From: Laura Gibbons
Sent: 24 June 2019 08:38
To: Planning.Responses <Planning.Responses@arun.gov.uk>
Subject: RE: Planning Consultation on BN/40/19/DOC

Engineers Comments Regarding Condition 4 Surface Water Drainage

Site Address: The Fallows Highground Lane Barnham PO22

Approval of details reserved by condition imposed under ref BN/50/18/PL relating to Condition No 4 - proposed surface water drainage.

SOAKAWAY SERVING 310 sq.m (HOUSE)

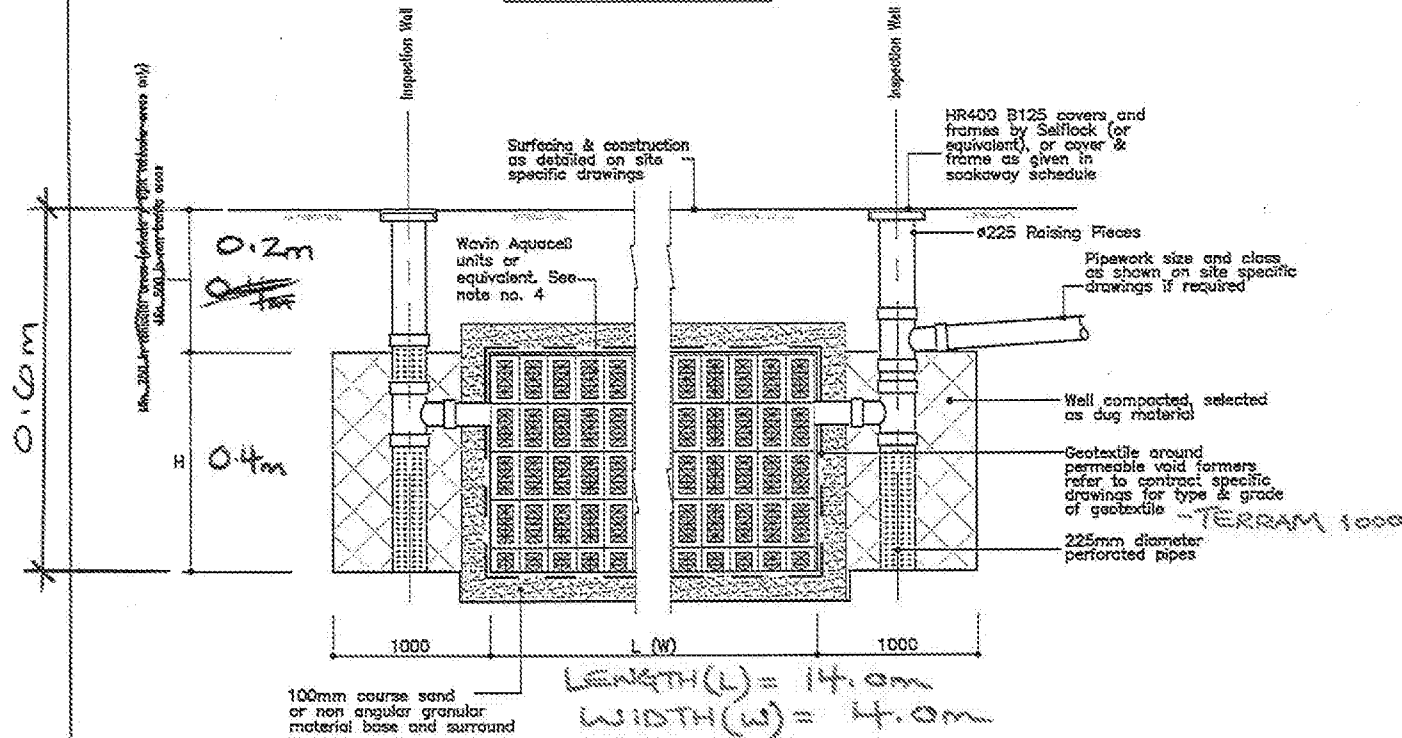
It is unclear from the supplied information if three consecutive infiltration tests were completed as is required. The information also states that a piezometer was installed to monitor ground water levels. These ongoing monitoring results have not been provided.

On this basis the soakway design has been amended as per attached.
